ADDENDUM NO. 2

To: All Planholders
From: Antonio L. Reyna, PE
Subject: Harlingen Economic Development Corporation
The Park at Roosevelt – EDA Grant Project
Date: September 3, 2024

- I. Replace Plan Sheets 6, 9 and 10 with attached Revised Plan Sheets 6, 9 and 10, Addendum No. 2, dated 9/3/2024.

HARLINGEN ECONOMIC DEVELOPMENT CORPORATION
 THE PARK AT ROOSEVELT - EDA GRANT PROJECT
 CONSTRUCTION PLANS
 PARKING LOT - PAVING & GRADING

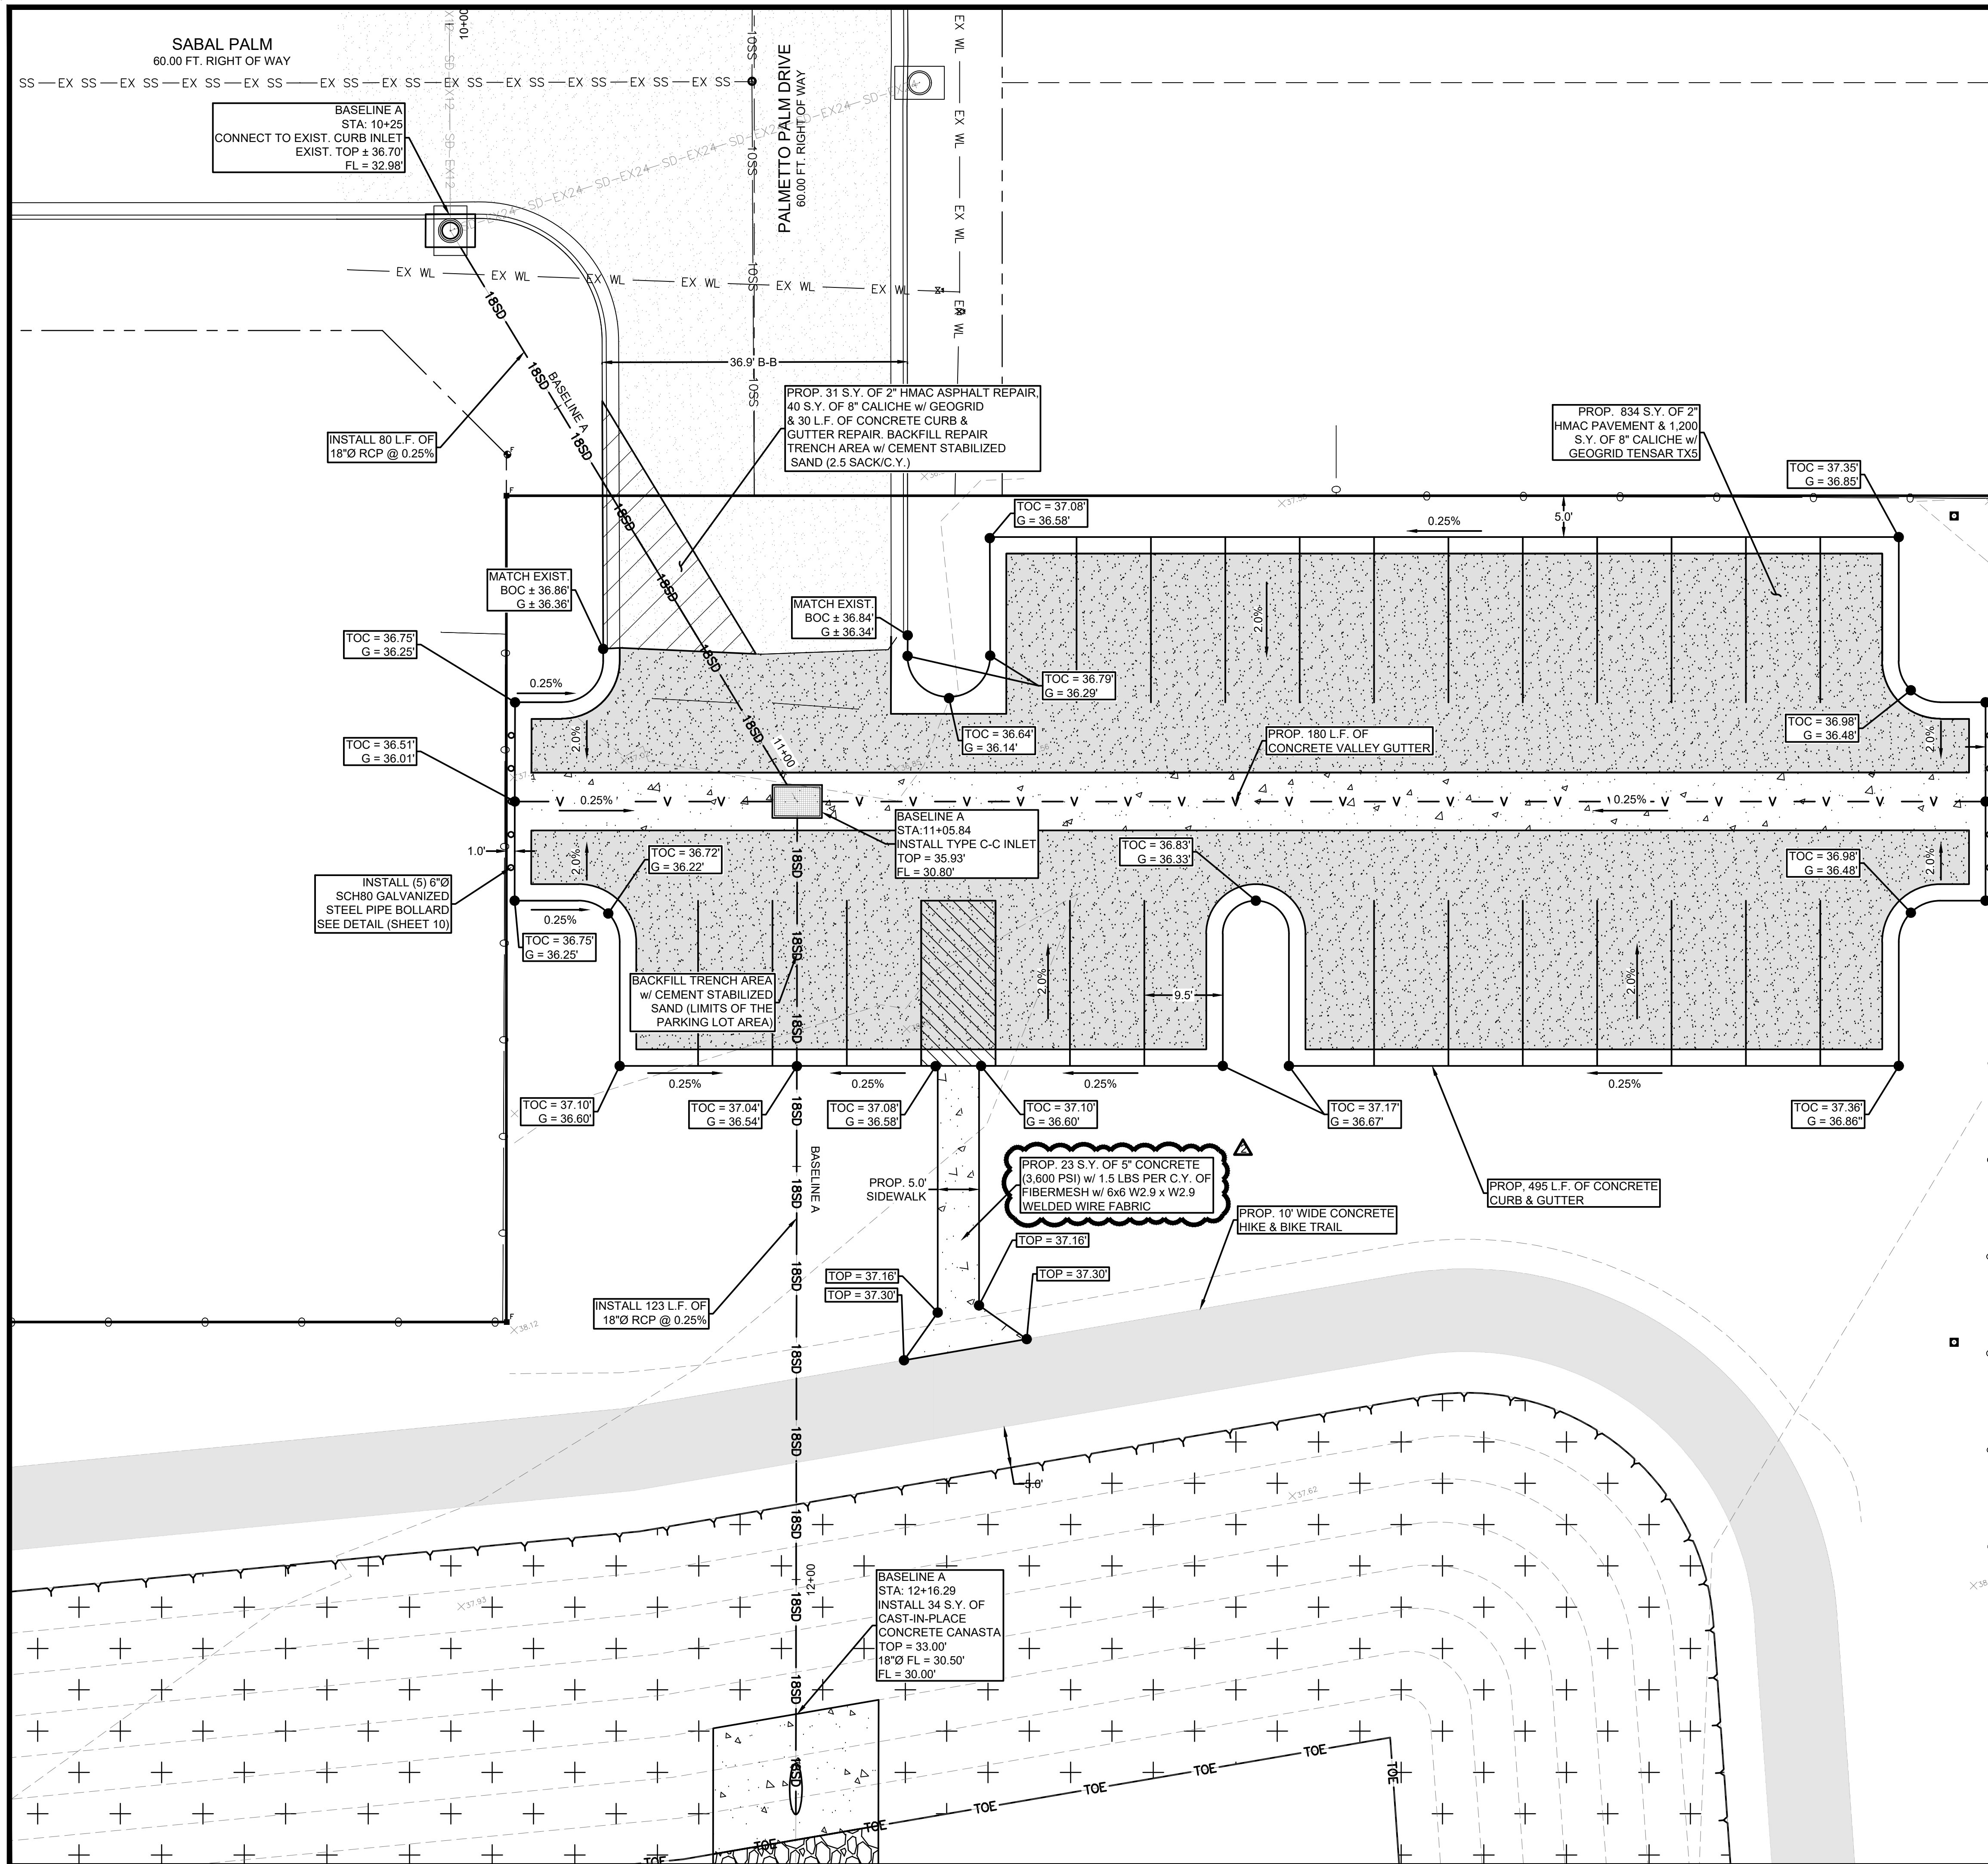
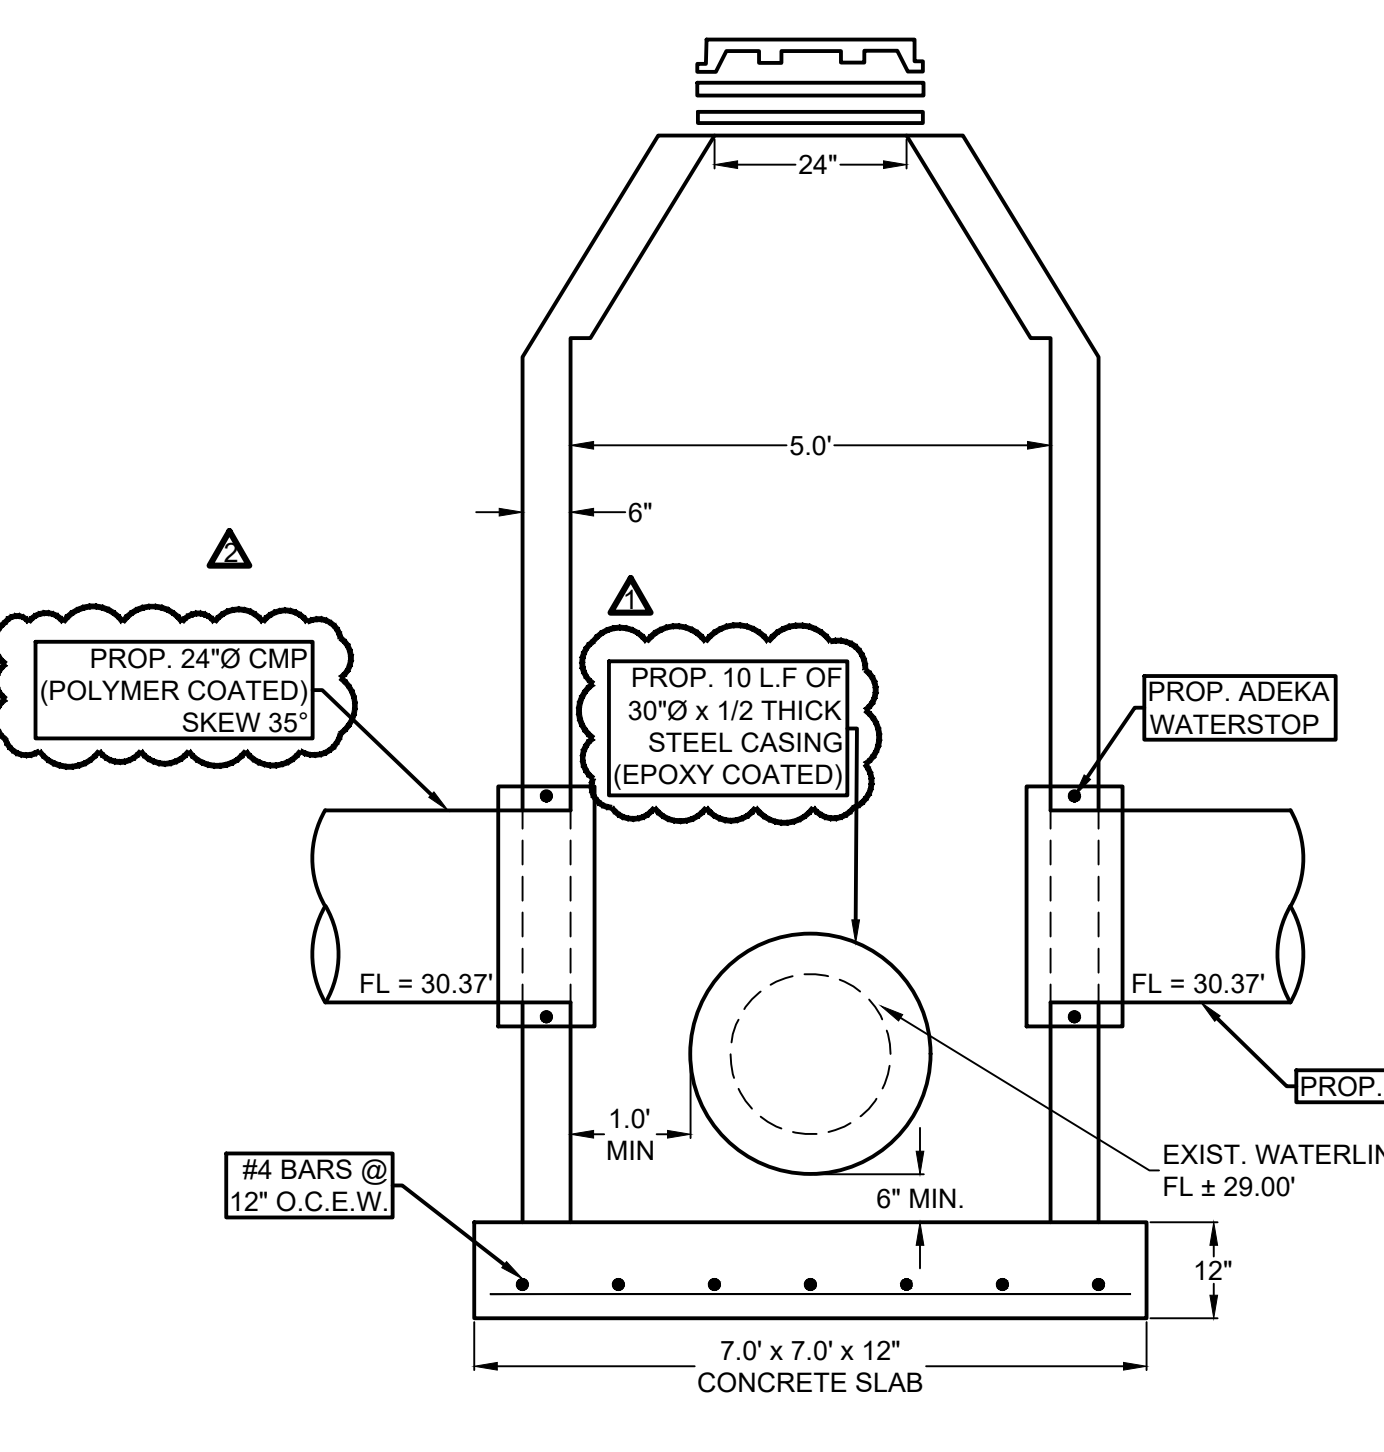
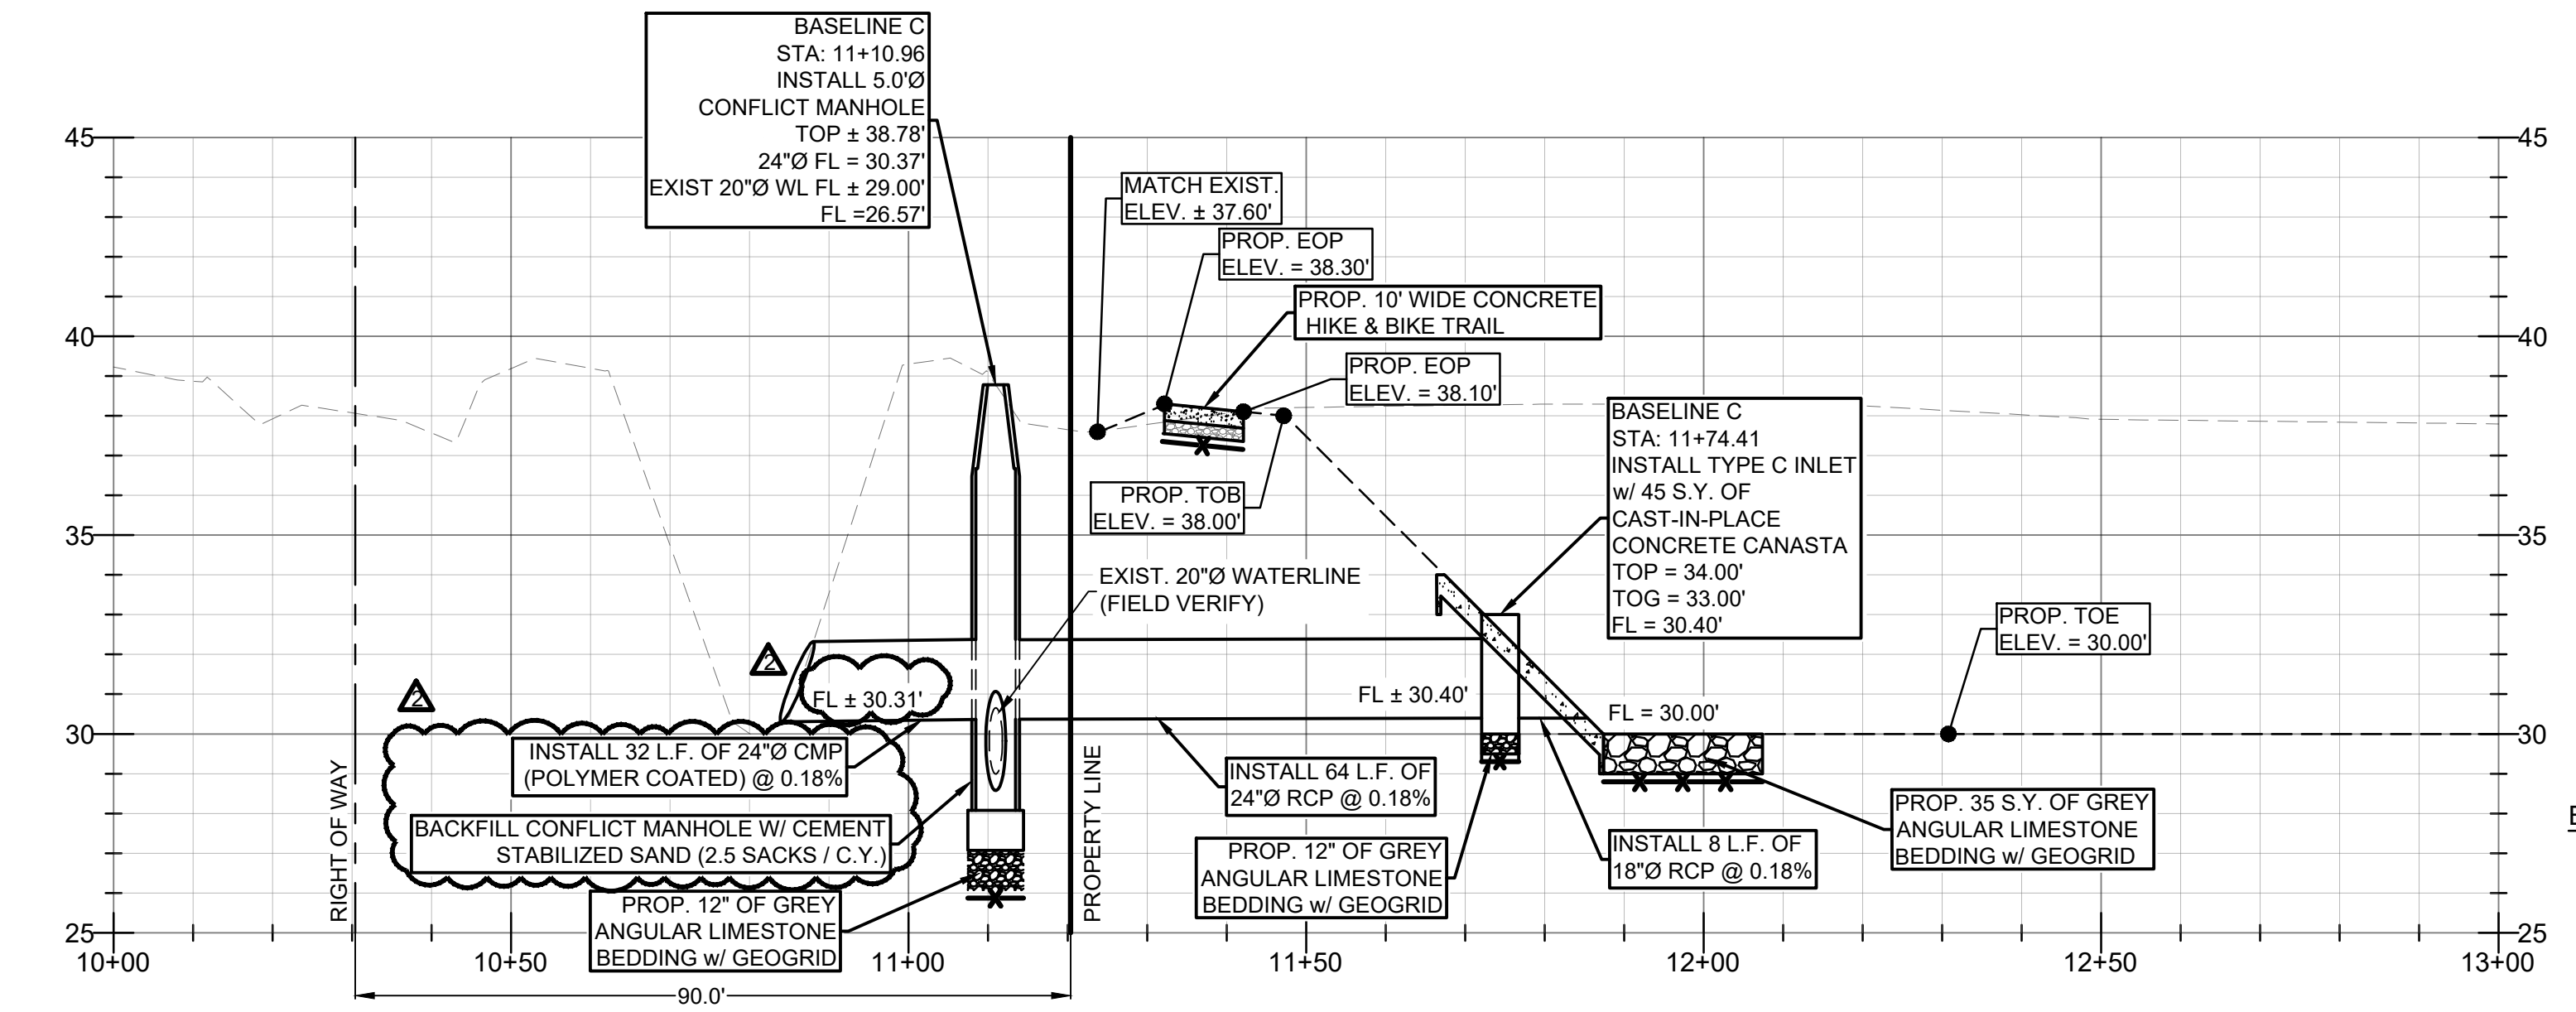
REVISIONS:
 09/03/2024
 ADDENDUM NO. 2
 FIBERMESH TO BE
 1.5 LBS PER C.Y.

CONCRETE SHALL BE CLASS "C" W/ 1.5 LBS PER C.Y. OF FIBER MESH W/ A 3600 P.S.I. MIN. COMPRESSIVE STRENGTH @ 28 DAYS. CURBS SHALL BE BACK FILLED IMMEDIATELY AFTER REMOVAL OF FORMS TO PREVENT TILTING. 2" DUMMY JOINTS @ 10' O.C. MAX.
